Drain: ANCHORAGE 246
Improvement: SEC 1
Operator: JES / JWL
Date: 9-15-03
CLASS URBAN
YEAR 1991

Drain Name: Anchorage

Re: **Anchorage Drain - Sec. 1 Arm**
Revised Report **

STORM SEWER AS-BUILT PLAN
THE ANCHORAGE SUBDIVISION
ON GEIST RESERVOIR
FISHERS, INDIANA

"Exhibit A"

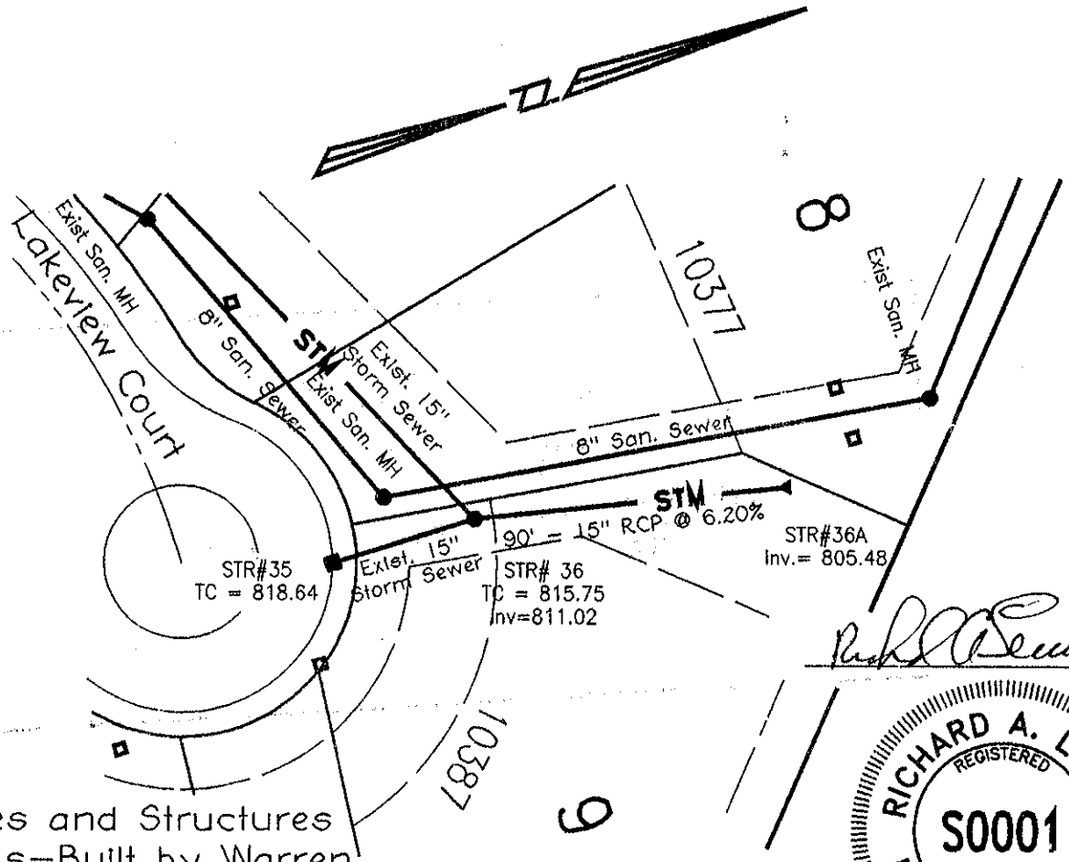
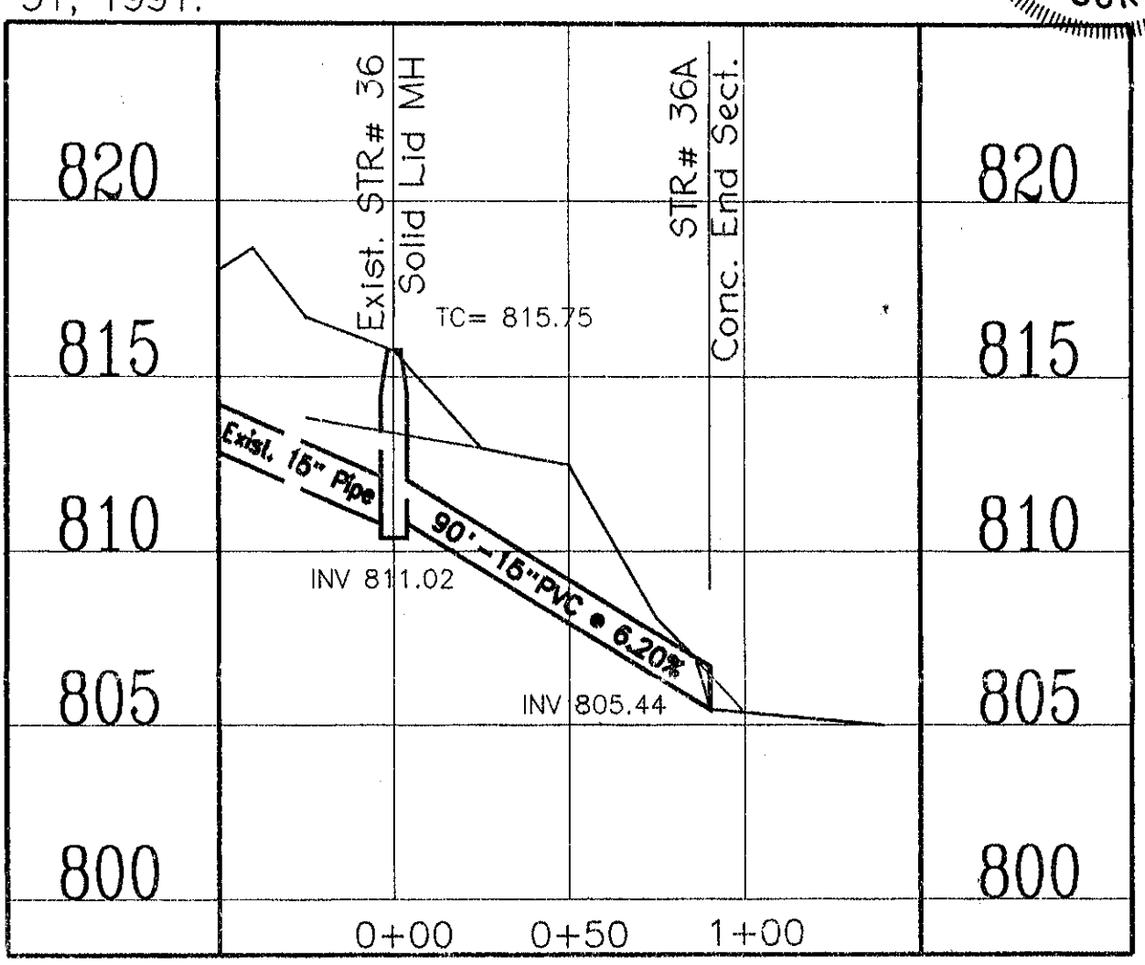
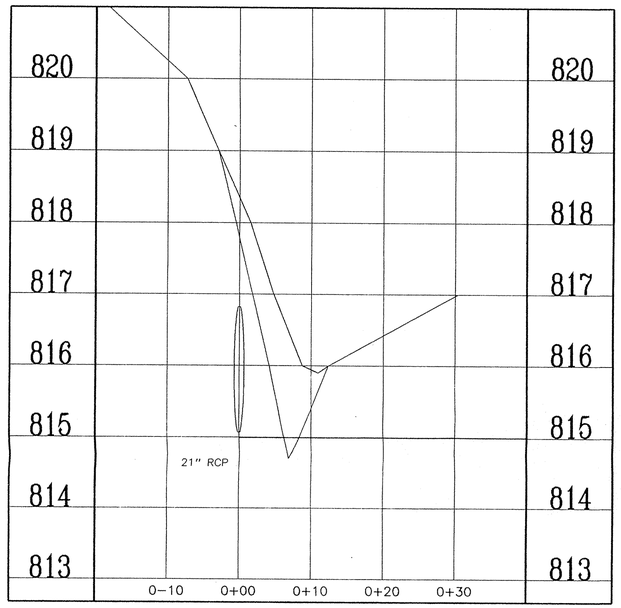
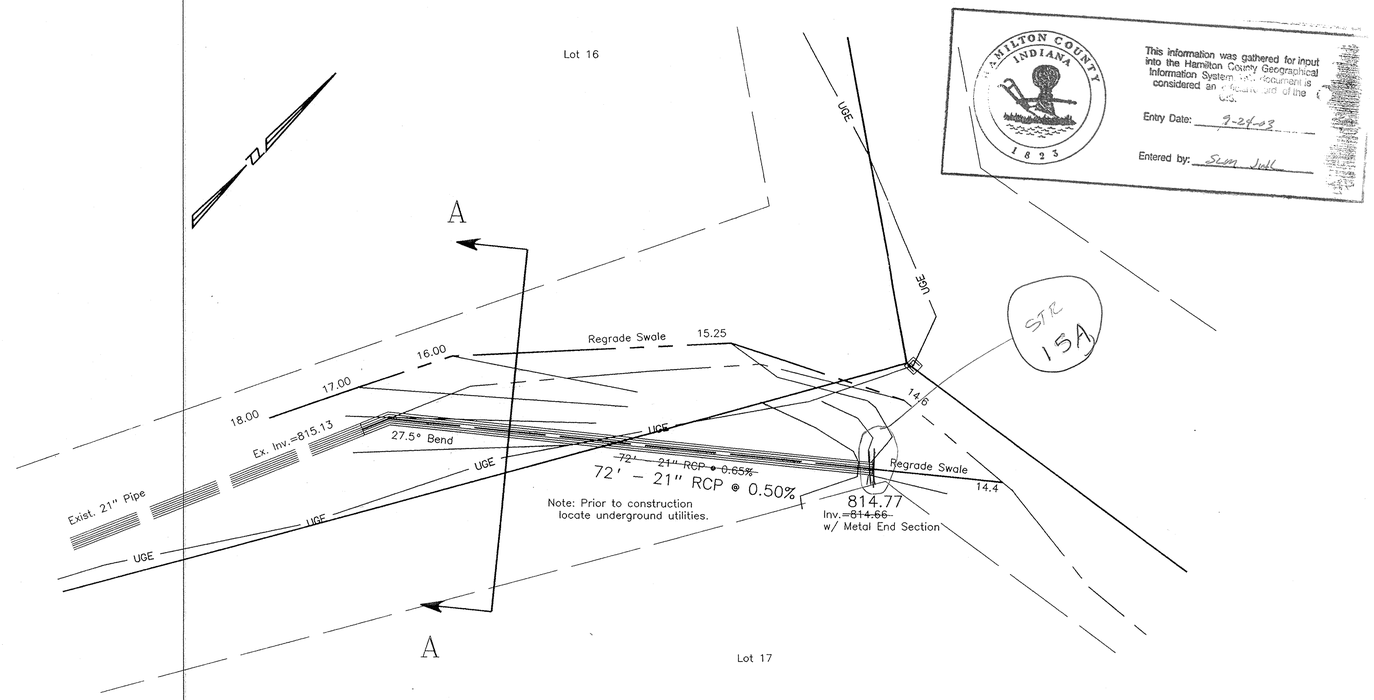
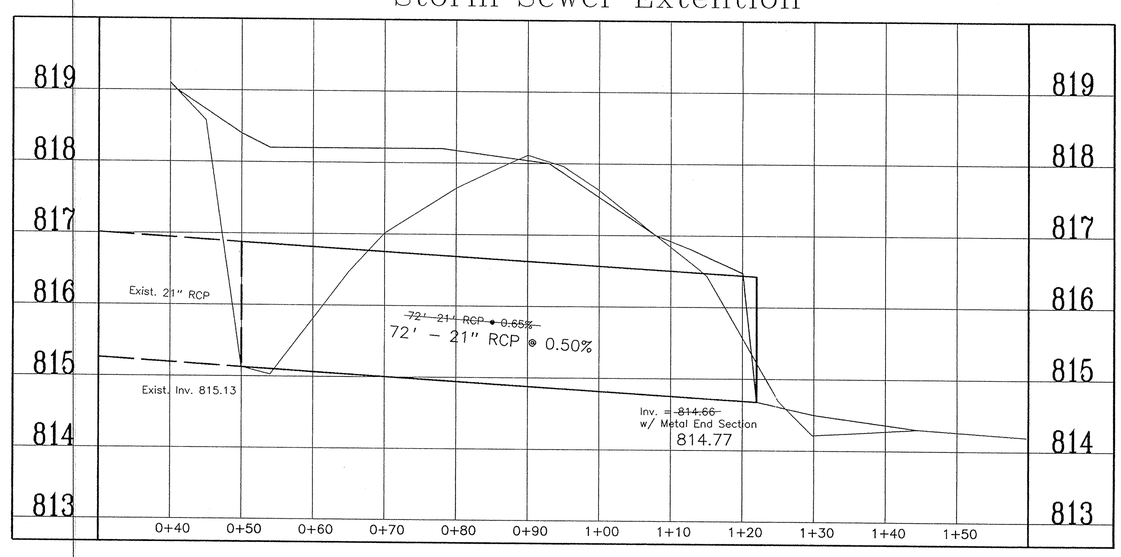
During construction, changes were made to the drain which will alter the plans submitted with my report for this drain dated April 30, 1991. The changes are as follows:
Structure 36-35 15" RCP was shortened from 45' feet to 40' feet.
Structure MES-24 15" RCP was lengthened from 115' feet to 127' feet.
Structure 19-MES 18" RCP was shortened from 175' feet to 165' feet.
Structure 17A-19 15" RCP was shortened from 285' feet to 267' feet.
Structure 25-24 15" RCP at 81' feet was not constructed.
Structure 15-MES 21" RCP was extended by 72' feet.
Structure 15-14 consists of 21" RCP at 50' feet which was not included on the original report.
Structure 28A-MES was added at 25' feet in length of 15" RCP.
Structure 22A-MES was added at 25' feet in length of 15" RCP.
Structure 36-MES was extended from 30' feet to 90' feet. This portion is noted on the asbuilt sheet provided by Falcon Engineering and labeled "Exhibit A."

The length of the drain due to the changes described above is now **5,639 feet**.

Map Correction-Field Verification

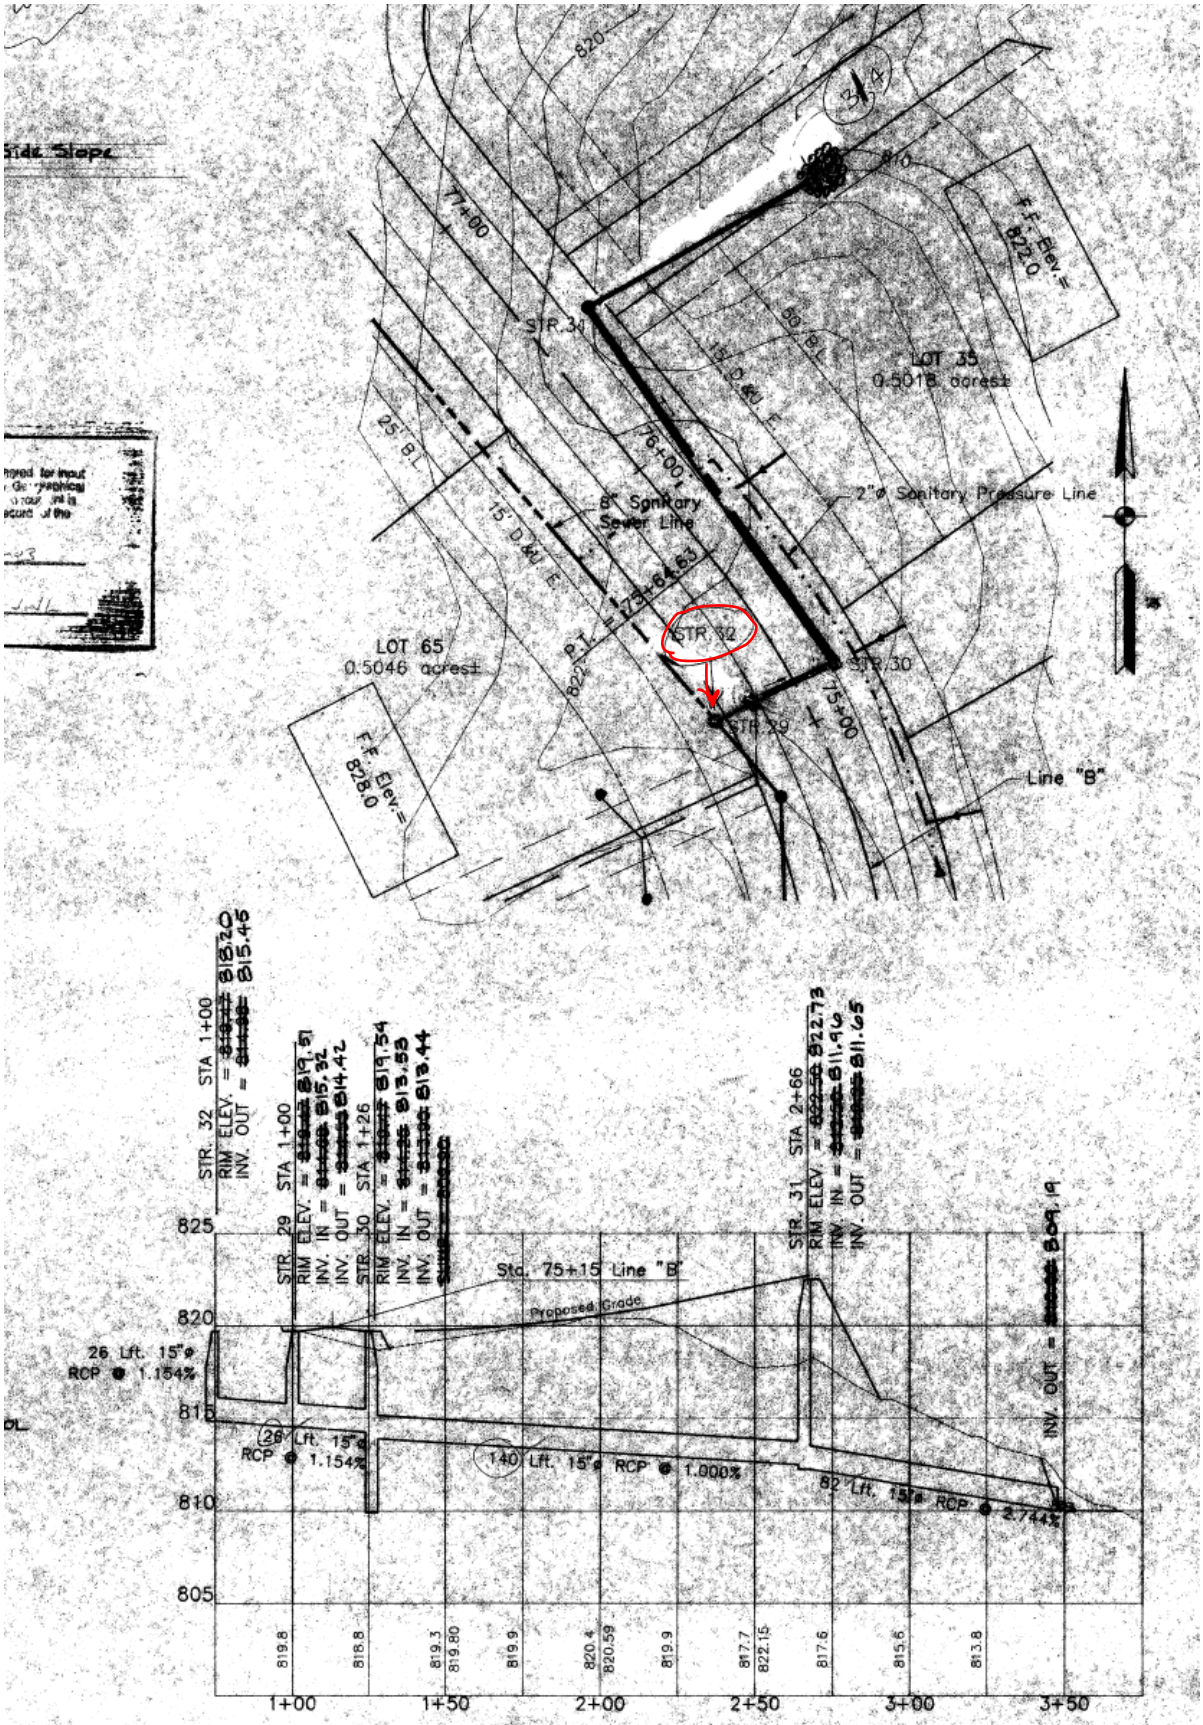
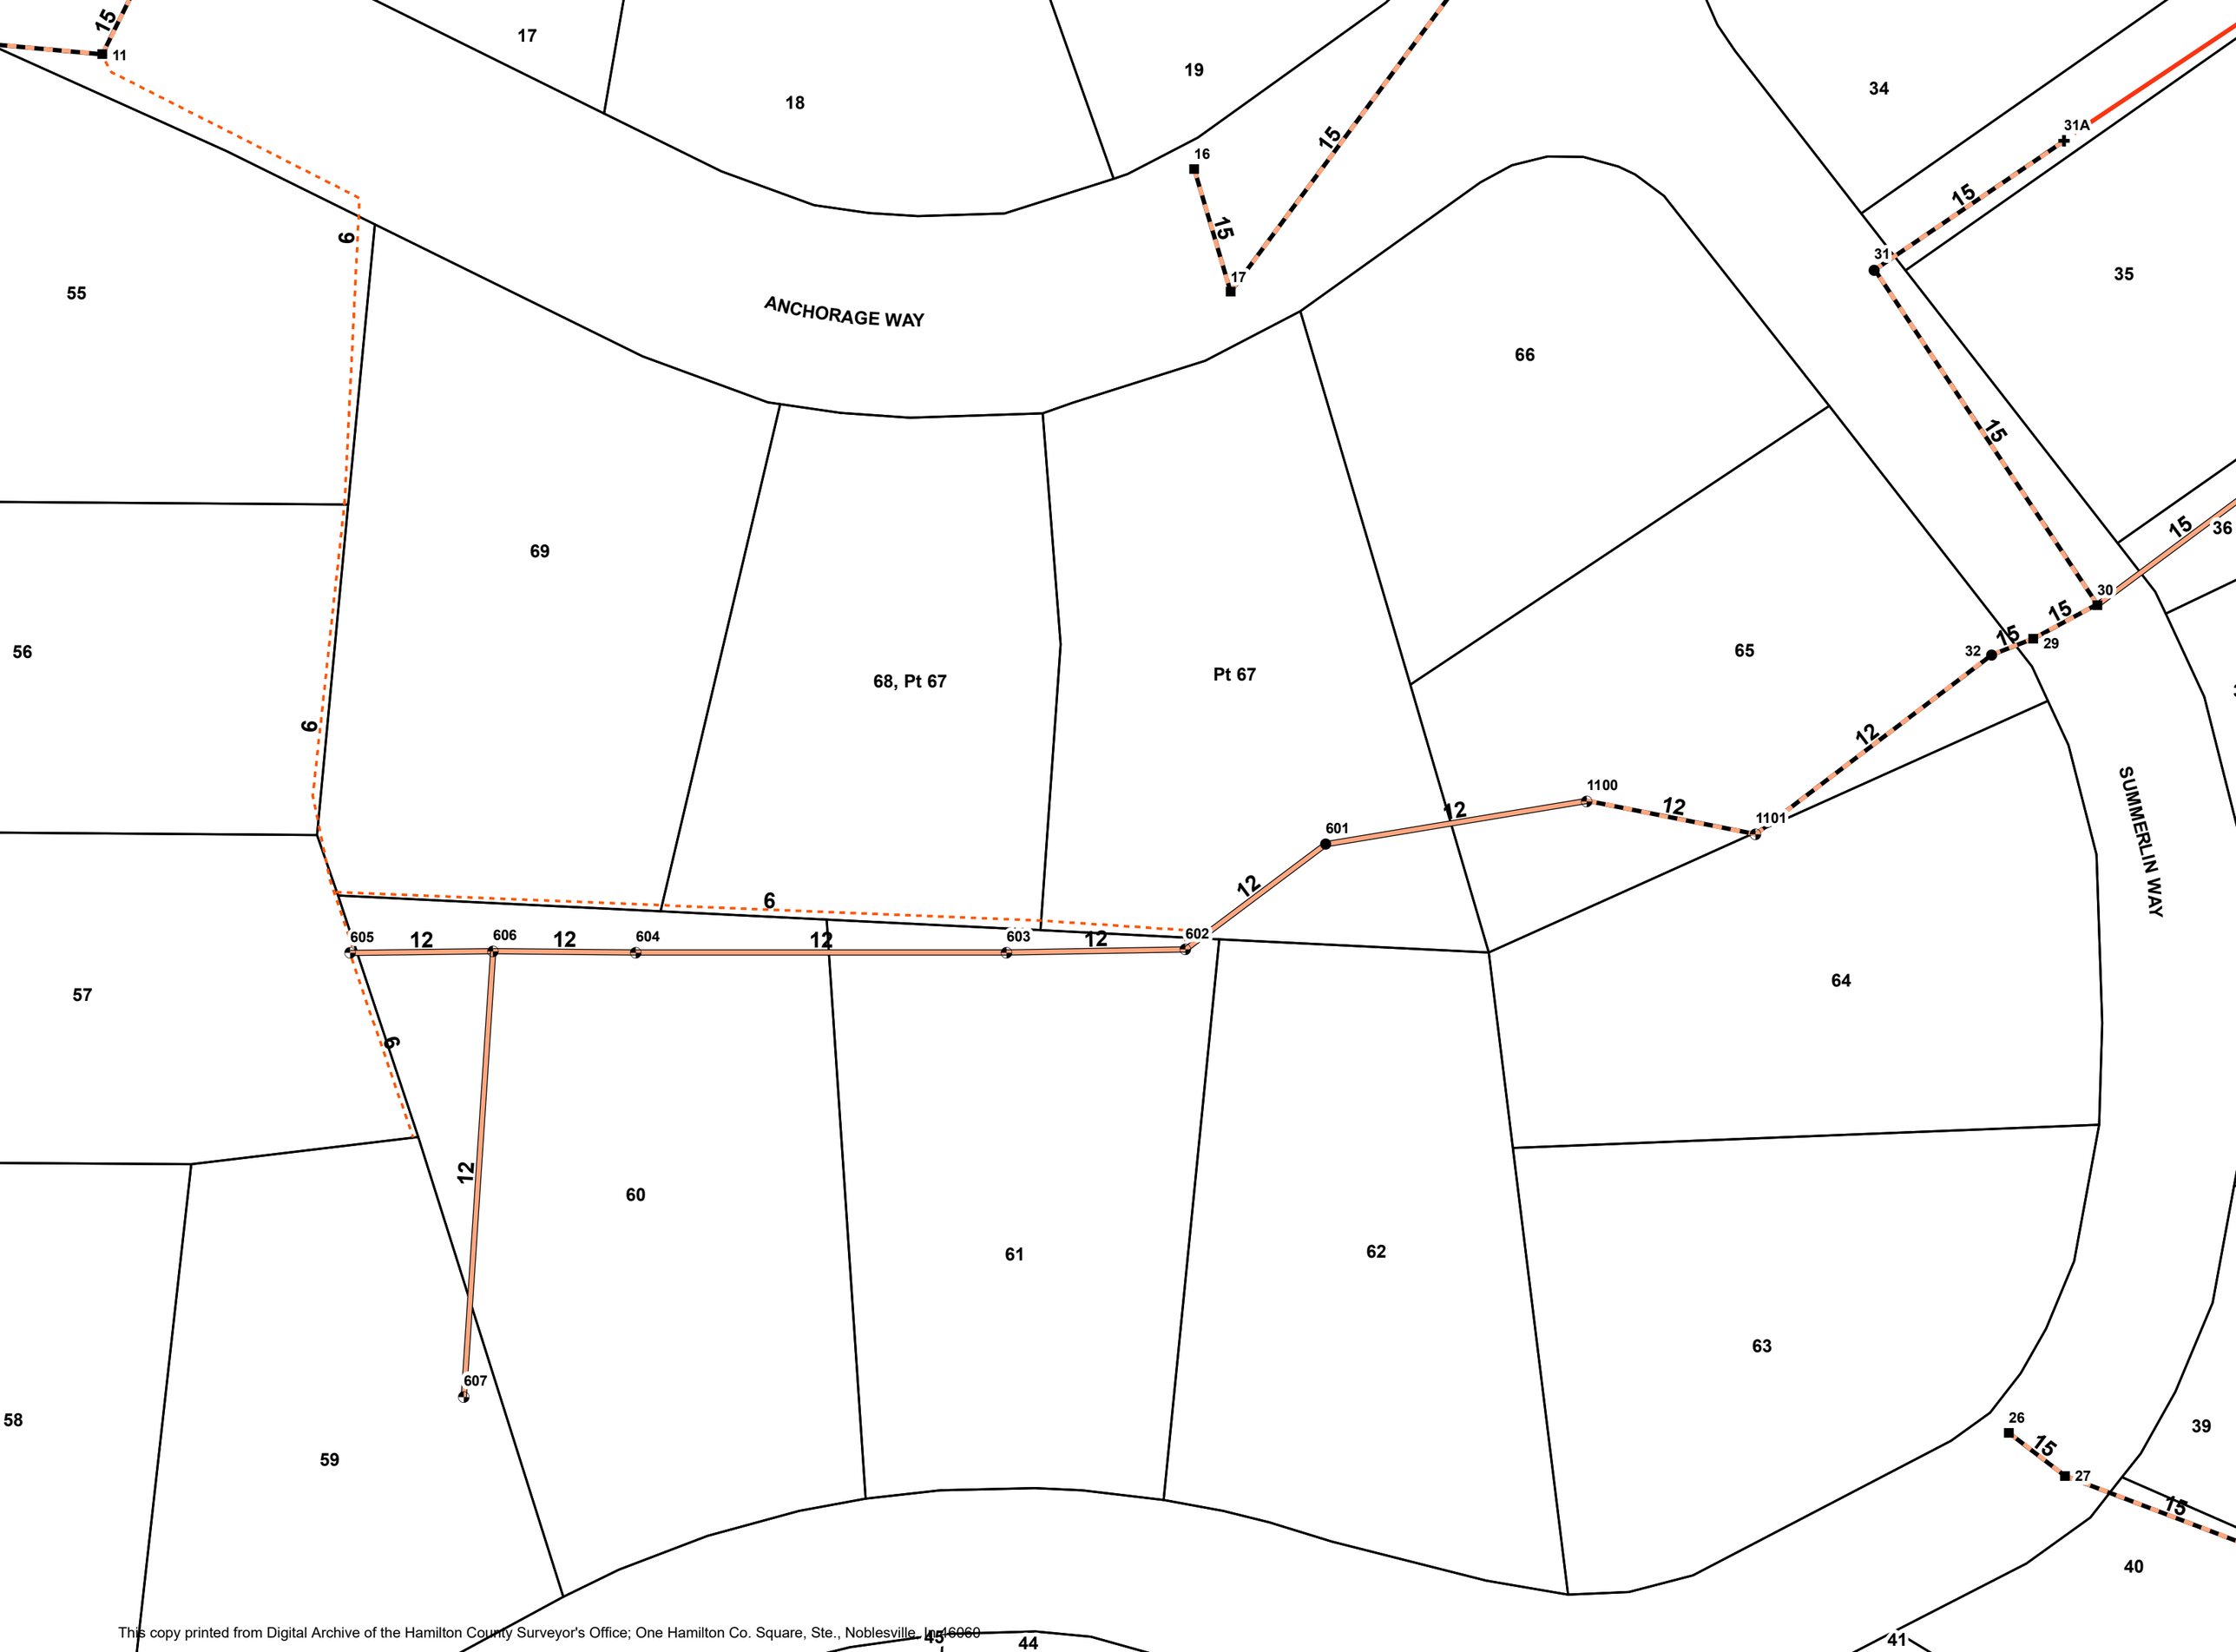
During the design phase for the 2019 reconstruction, it was determined that a portion of the original Anchorage Sec. 1 Drain had been modified. The modification occurred between 1994 and 1996 on the south property line of Lot 65. The drain was extended in a westerly direction from existing structure 32. This consisted of setting two structures and running 163 feet of 12" RCP. This 12" RCP installed serves as the outlet for the new 12" HDPE installed for the reconstruction across lots 60-55, and 67-69.

Then, during the 2019 reconstruction, the instillation of the 12" HDPE removed the existing 6" SSD across Part Lot 67 and Lot 65. The 6" SSD ran across the south property lines. Therefore, 221 feet of 6" SSD was removed.

New Length: 5890
